NUMBER: 25-005-13 REV. A

I/M Readiness Check Continues To Indicate OBD System Is Not Ready For I/M Testing (X51 Lifetime Warranty Extension)

This bulletin involves modifying wiring in the Power Distribution Center (PDC).

2005 - 2006 (TJ) Wrangler

Fig. 1 TWO 20 GA. PK WT WIRES IN CAVITY A13

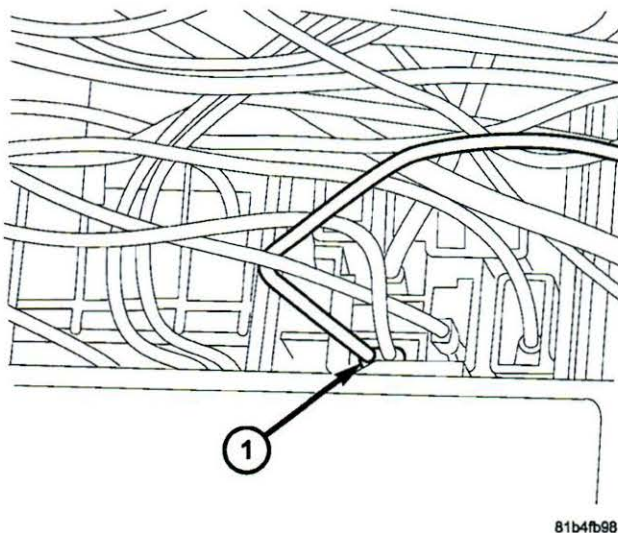
1. Remove and isolate the positive and negative battery cables from the battery.
2. Remove the Power Distribution Center (PDC) cover from the PDC.
3. Locate the ASD (Auto Shut Down) and the Fuel Pump relays in the PDC.
4. Remove the two nuts used to secure the positive battery cable to the PDC. Remove the positive battery cable from the PDC.
5. Remove the PDC from its bracket and remove the cover from the bottom of the PDC to expose the underside wiring.
6. Locate the terminal end in PDC cavity A13 that connects to the ASD relay pin 85. Two 20 gauge wires, each of PK/WT color, are crimped to this terminal end (Fig. 1).

Fig. 2 CUT ASD 20 GA. PK WT TO FUEL PUMP

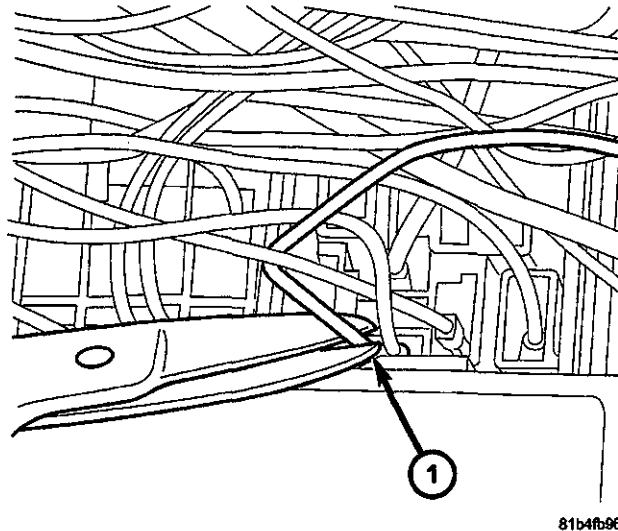
7. At PDC cavity A13 (ASD), locate the one PK/WT wire that connects to the fuel pump relay terminal.
8. Cut the PK/WT wire, that connects to the fuel pump relay, as close to the PDC cavity A13 terminal as possible (Fig. 2).

Fig. 3 CUT ASD 18 GA. RD YL WIRE IN CAVITY A15

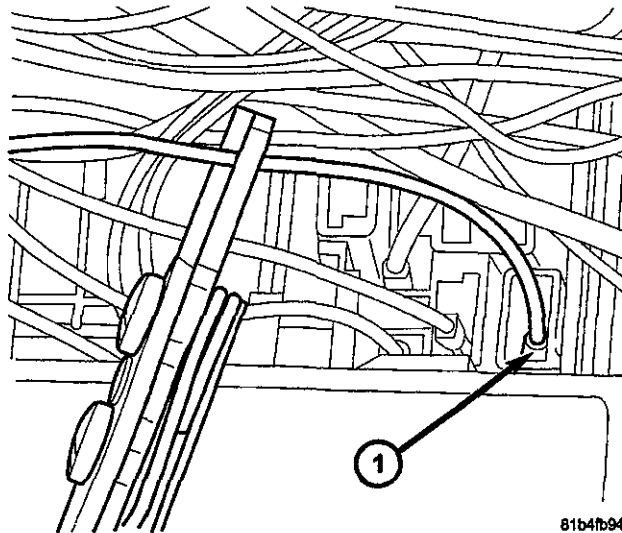
12. Locate the RD/YL 18 gauge wire connected to the terminal end in PDC cavity A15. This wire connects the ASD relay pin 30 to fuse #9 (ASD power) in the PDC.
13. Cut this wire approximately 2 inches from the PDC cavity A15 terminal (ASD relay pin 30) (Fig. 3).

Fig. 4 COMPLETED WIRE SPLICES

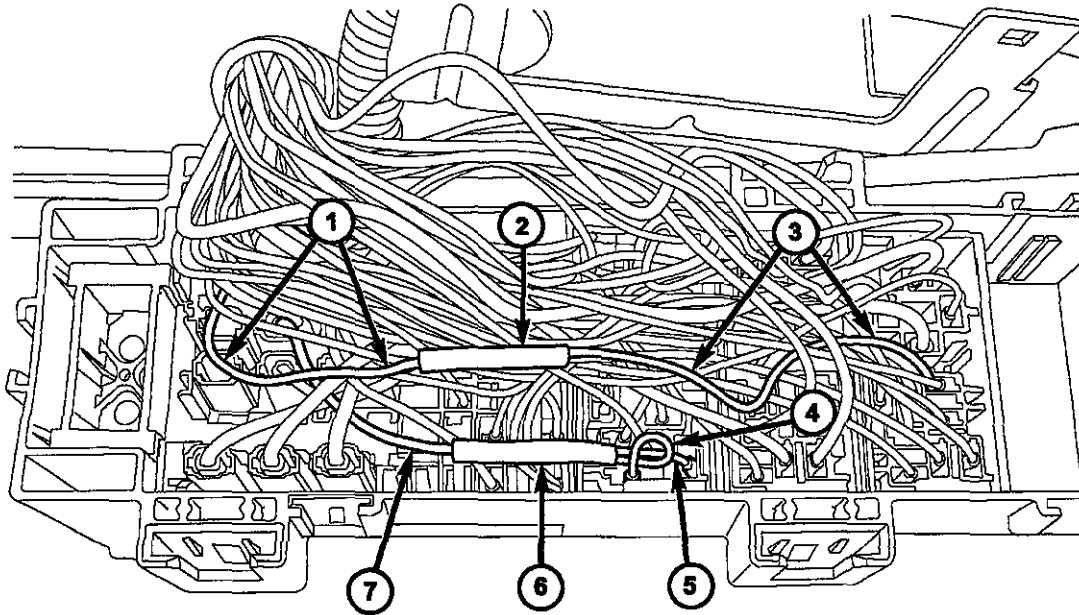
-
14. Strip approximately 0.25 inches of insulation from both ends of the RD/YL wire cut in Step #13.
 15. Splice the two RD/YL wires to the one remaining PK/WT wire (2 inch lead at A13) together (Fig. 4). **Be sure to slide shrink tube over wire before crimping.** Splice the wires with kit p/n 05018395AA.
 16. After both splices are complete, solder crimp splices with non-acid core solder.
 17. Slide shrink tube over soldered splices and shrink with a heat gun until sealant is visible on both ends of the splice (Fig. 4).
